MECKLENBURG COUNTY
Park and Recreation Department

MEMORANDUM

RE: Rezoning Petition #2012-081 (Lower McAlpine Creek Greenway)
NRI Communities/Charlotte, LLC (PID #223-231-47)

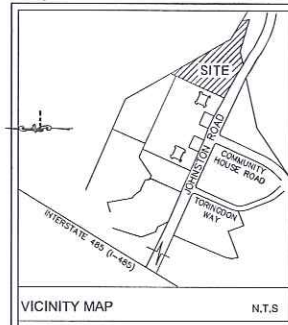
MCPR recognizes and accepts Note #19 from the original rezoning petition #2007-103 for access to the Lower McAlpine Creek Greenway. We request all greenway access easements be a minimum of 60' wide for trail constructability and maintenance. In addition, we request dedication of floodplain area adjacent to the creek as shown on the attached parcel as a minimum. The entire floodplain would also be acceptable.

DATE: 08.25.12
SCALE: HORIZ: 1" = 40'
JOB NO. X12029.00
SHEET: RZ 1.0

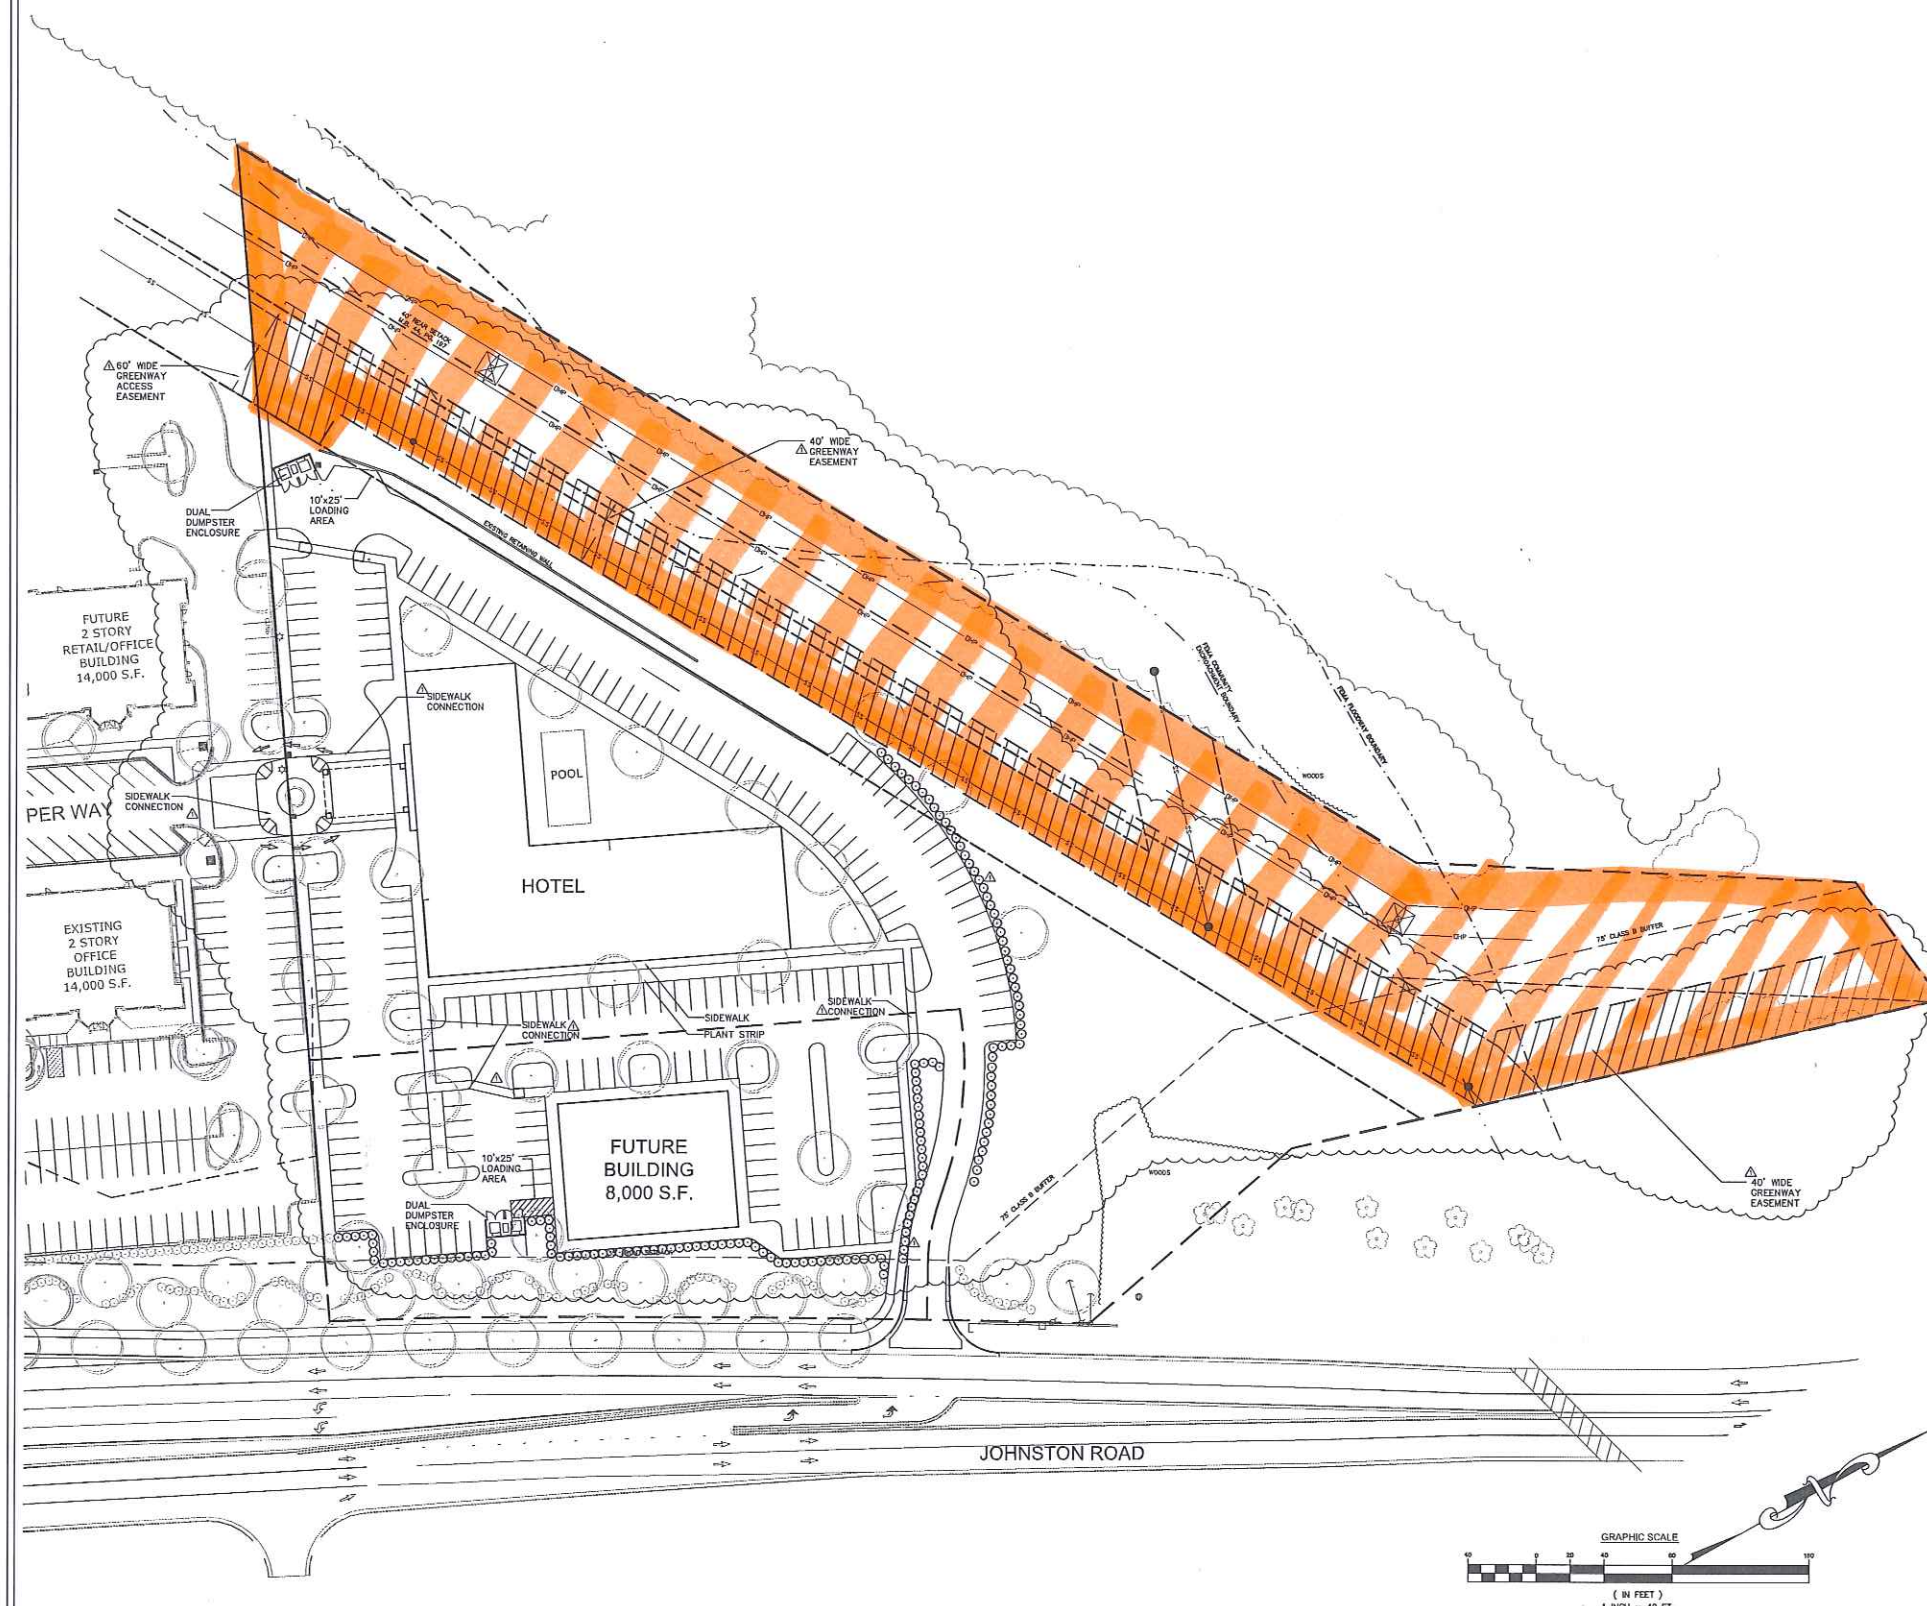
REVISED 08.24.12		REVISIONS PER PLANNING STAFF COMMENTS	DATE
1

- c. The Site will comply with the Tree Ordinance.
 - d. A greenway path easement as generally depicted on the site plan shall be provided by the petitioner/owner. The minimum width of the easement shall be 40 feet as indicated on the site plan. The minimum width of the easement shall be increased to 60 feet as indicated on the site plan. The location of the easement is shown only to depict internal streets in the development. It is intended for this easement to connect from the northern end of the Site at Johnston Road to the proposed public pathway. The final, precise location of the easement shall be determined at a future time depending upon site constraints, other public easements, public improvements, structures, etc. In no event shall the easement be located in such a manner as to negatively impact or conflict with developer/petitioner planned improvements, buildings, parking areas, sidewalks, etc. As outlined by the proposed site plan, a deed easement shall be provided prior to the issuance of a building permit in association with the aforementioned hotel use or within two years of the approval of this site plan amendment, whichever occurs first.
